Planning Board – Monday, April 27, 2020, 6:30PM

S-11-13, Modification #1 – Subdivision Modification – 0 Old Walpole Road

SPR-03-17 MOD. 3 – SITE PLAN REVIEW – 17 BRADCO ST, BRANCH & BLADE BREWERY

RE: Site Plan Review, 17 Bradco Street, Branch and Blade Brewing

Figure 2. Image of a section of the proposed plan with the wetland area shaded in blue and the 30-foot Surface Water Protection buffer outlined in orange.

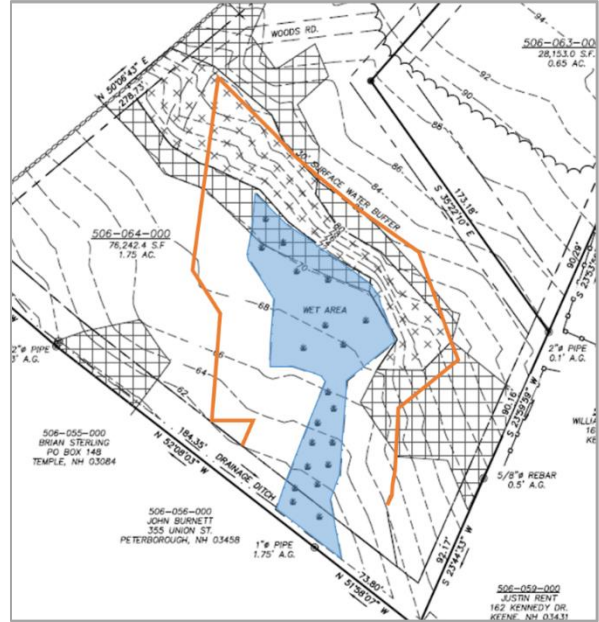
16. Wetlands & 17. Surface Waters: Wetlands are present on the 1.75-acre lot, as shown on the proposed subdivision plan submitted by the applicant and shown in Figure 2. This wetland area was delineated by a NH certified wetland scientist in August 2013. The proposed subdivision plan also shows the 30-foot surface water protection buffer, and includes a note which states “City permits and approvals will be necessary for any work within the surface water protection overlay buffer” (see Note #14). However, the wetland buffer would not need to be crossed or otherwise disturbed in order to develop on the portion of the lot closest to Old Walpole Road, which is outside the Surface Water Protection Overlay District. No other surface waters are present on the site. This standard appears to be met.

GRADING & EROSION CONTROL PLAN

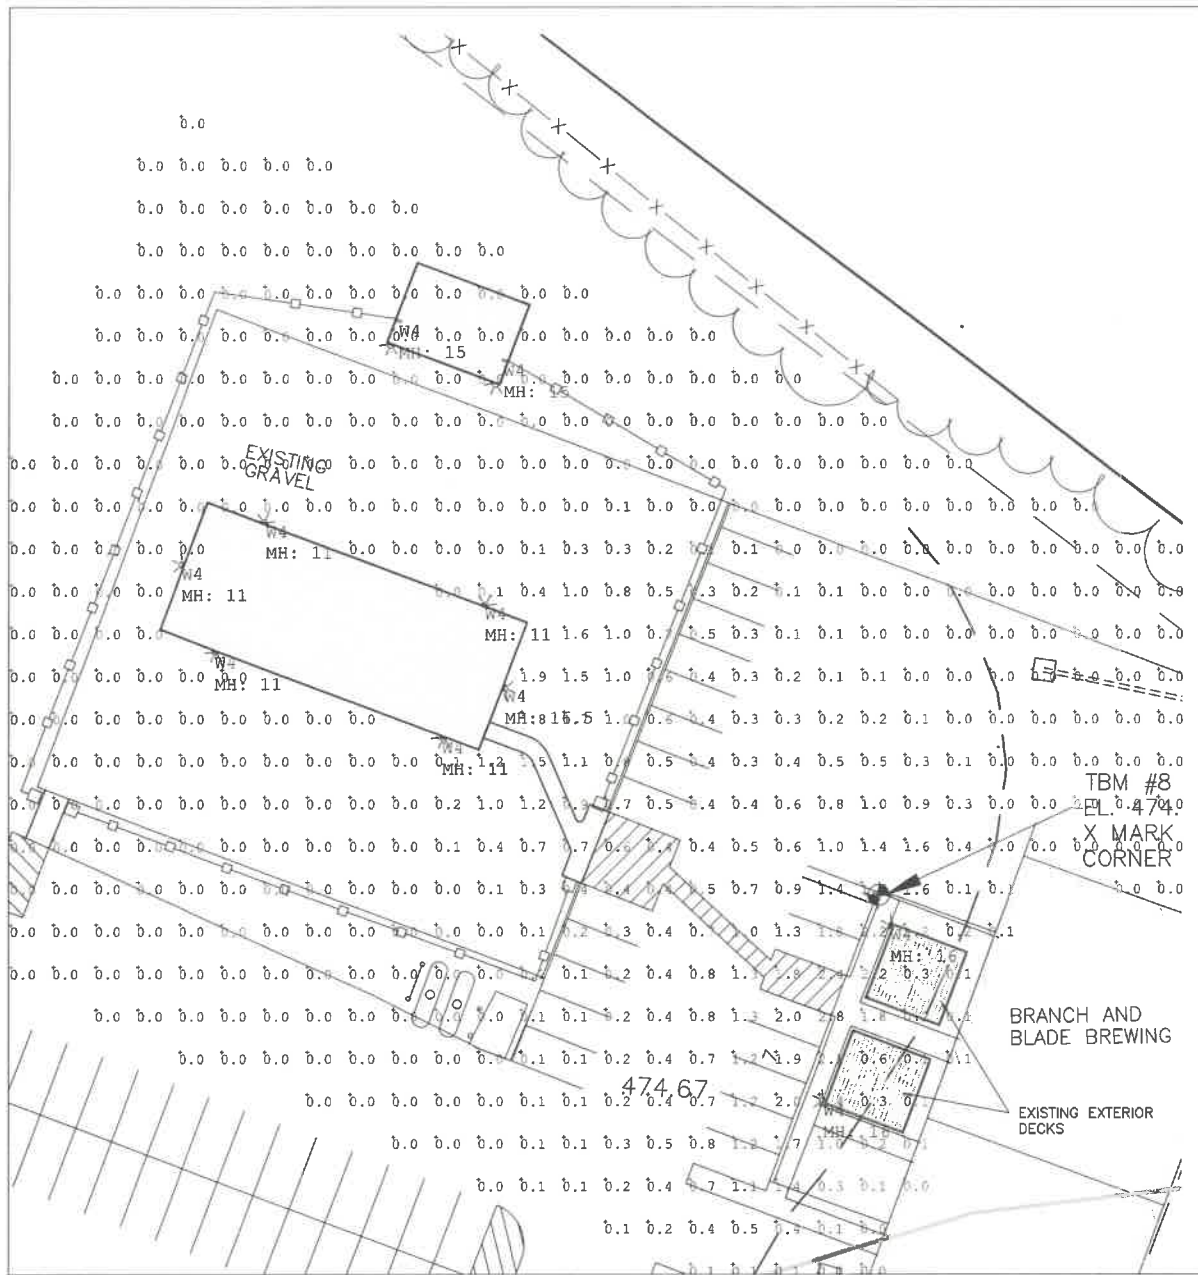
2. **Sedimentation and Erosion Control:** The Applicant notes in their narrative and demonstrates on the Grading and Erosion Control Plan (Sheet 3) that silt fencing will be installed at the edge of the disturbed

area (to the north of the proposed stage) to control stormwater runoff and to prevent sediment from leaving the site. This Plan also contains notes for a suggested erosion control sequence, and a detail for a straw waddle to be installed along the silt fencing. This standard appears to be met.

4. A note has been added to the plan to show the limits of the loaming and seeding. The limit line will be the proposed fence around the pavilion area.

LIGHTING PLAN

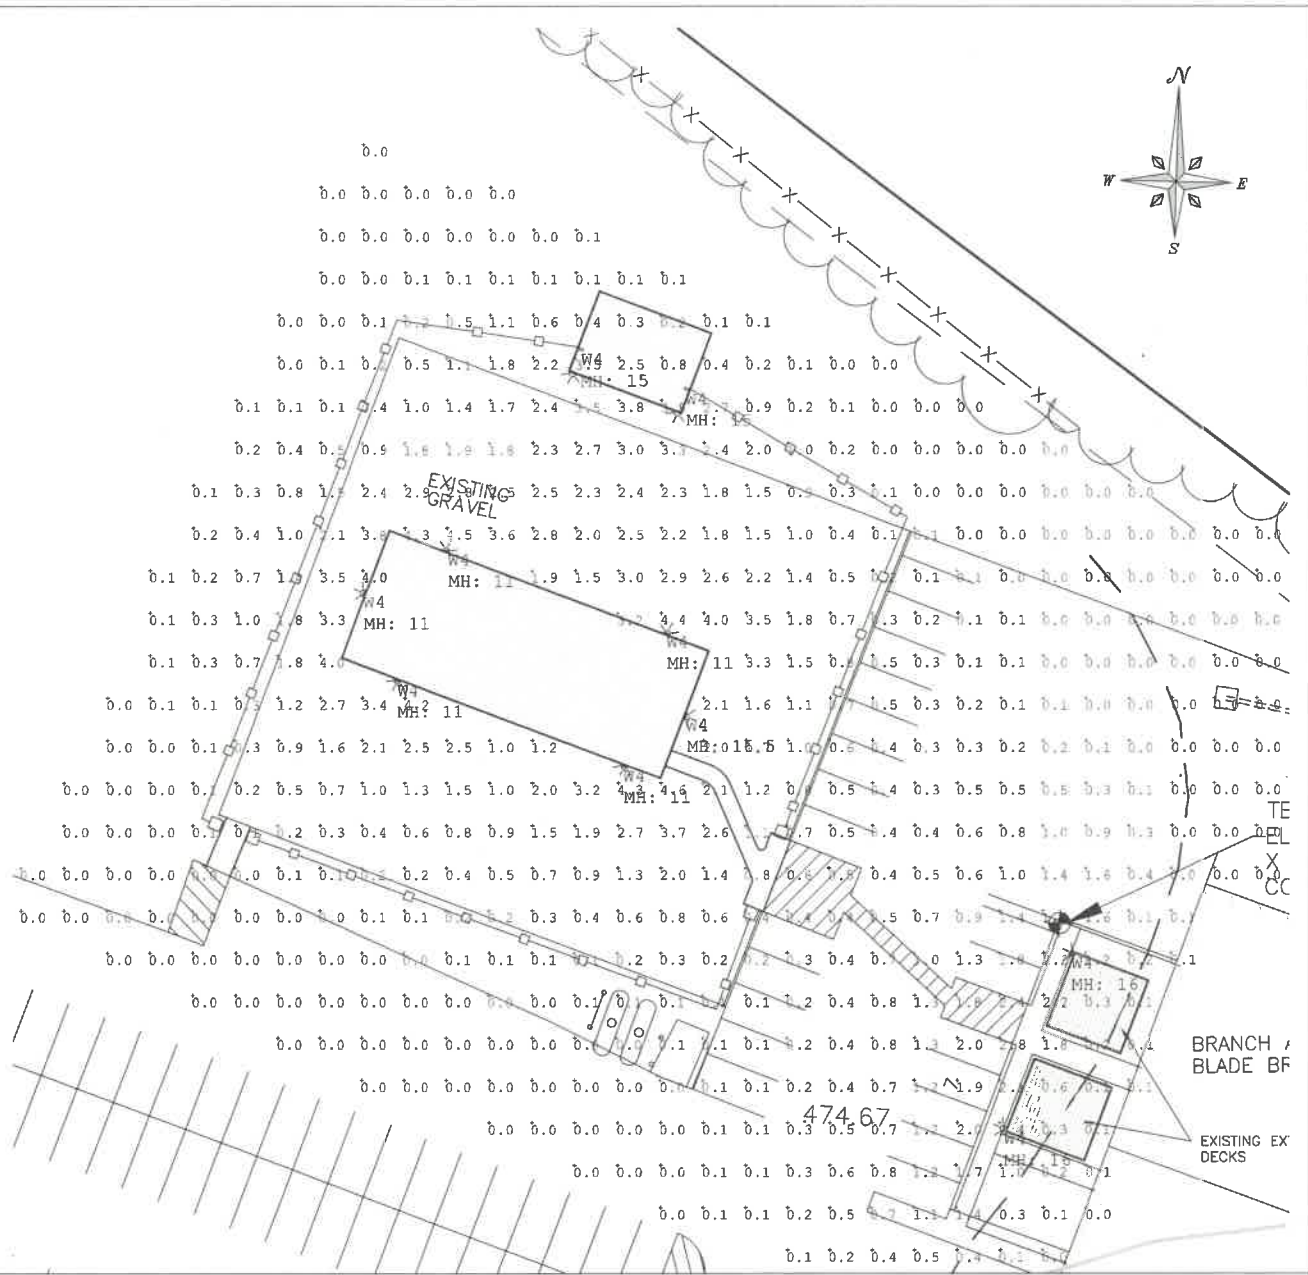
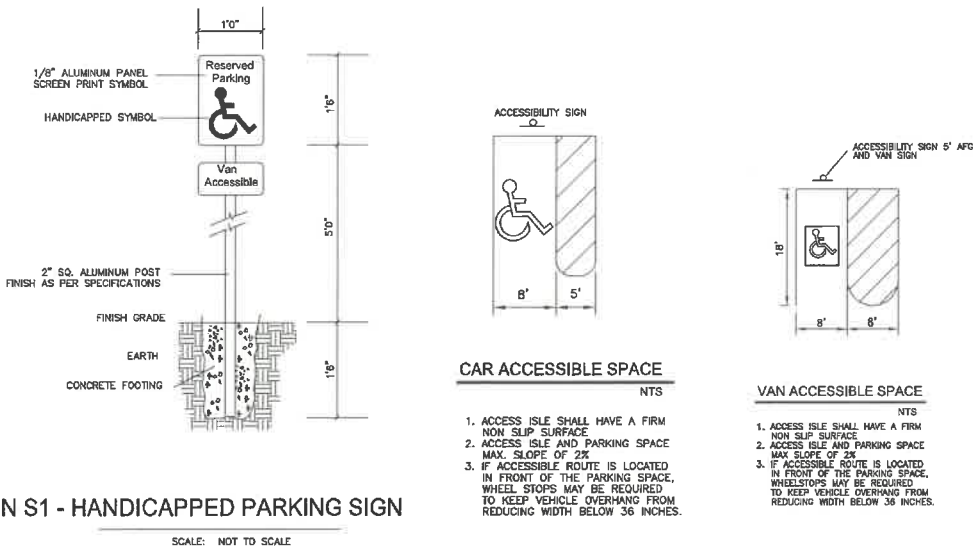
The photometric plan provided by the Applicant shows that the walkway connecting the pavilion to the main entrance of the Brewery would have an average light level of 1.13 footcandles (0.63 footcandles in excess of the 0.5-footcandle average limit) and would have a maximum walkway lighting level of 2.6 footcandles (0.6 footcandles in excess of the 2-footcandle maximum).

5. We would like to request a waiver of the lighting standard to allow light levels above 2 foot candles and to allow an average illumination above 0.5 foot candles for the walkway from the main building to the outdoor pavilion. The pathway crosses an existing parking area and travel way for vehicles. The pathway is also adjacent to areas that will be used for outdoor seating. We feel the higher light levels area warranted for safety of pedestrians crossing the drive aisle of the parking lot and to provide lighting in the adjacent seating areas.

NORTH ELEVATION

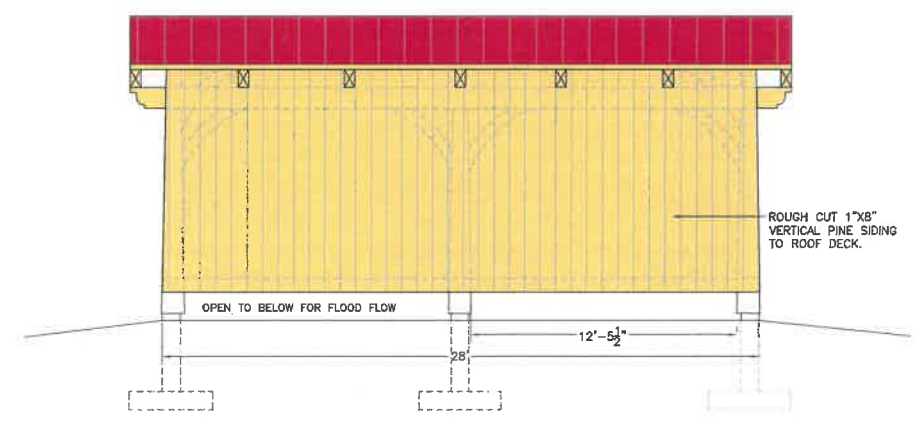
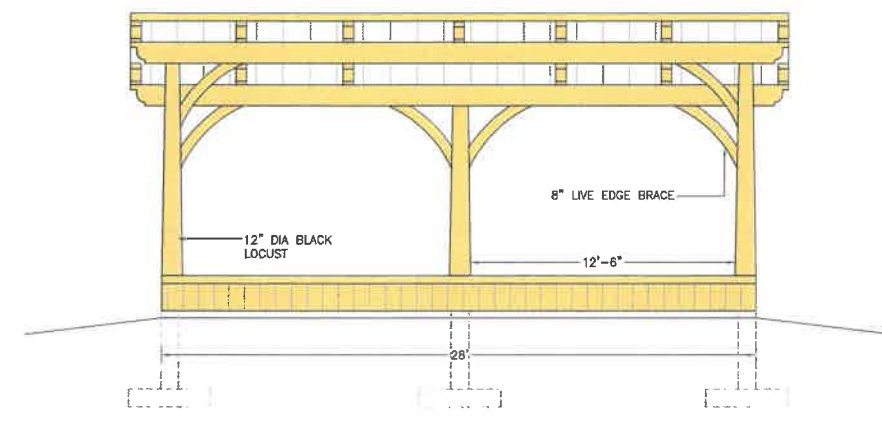
6. Attached please find an elevation drawing of the stage building for the project. This building will also be post and beam construction using the same colors and materials as the proposed pavilion construction. The stage will be enclosed on three side with vertical rough cut pine board siding. The siding will be sealed with a natural clear sealer. The siding will be raised up a minimum of 12 inches above the existing grade for flood flow.
